COUNTAX™

SERVICE BULLETIN

14-09-13

MK3 SNOWBLADE UPGRADE KIT

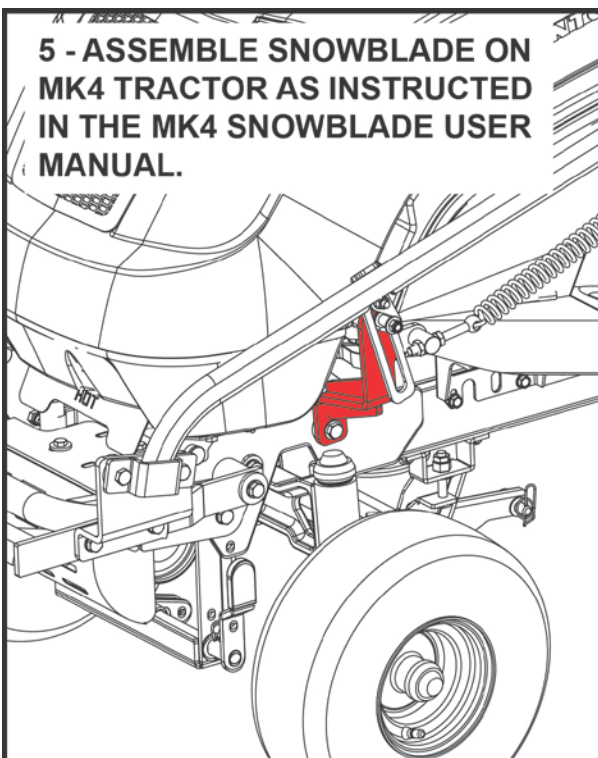
5 - ASSEMBLE SNOWBLADE ON MK4 TRACTOR AS INSTRUCTED IN THE MK4 SNOWBLADE USER MANUAL.

6 - ENSURE HANDLE BRACKET IS FITTED IN NEW POSITION.
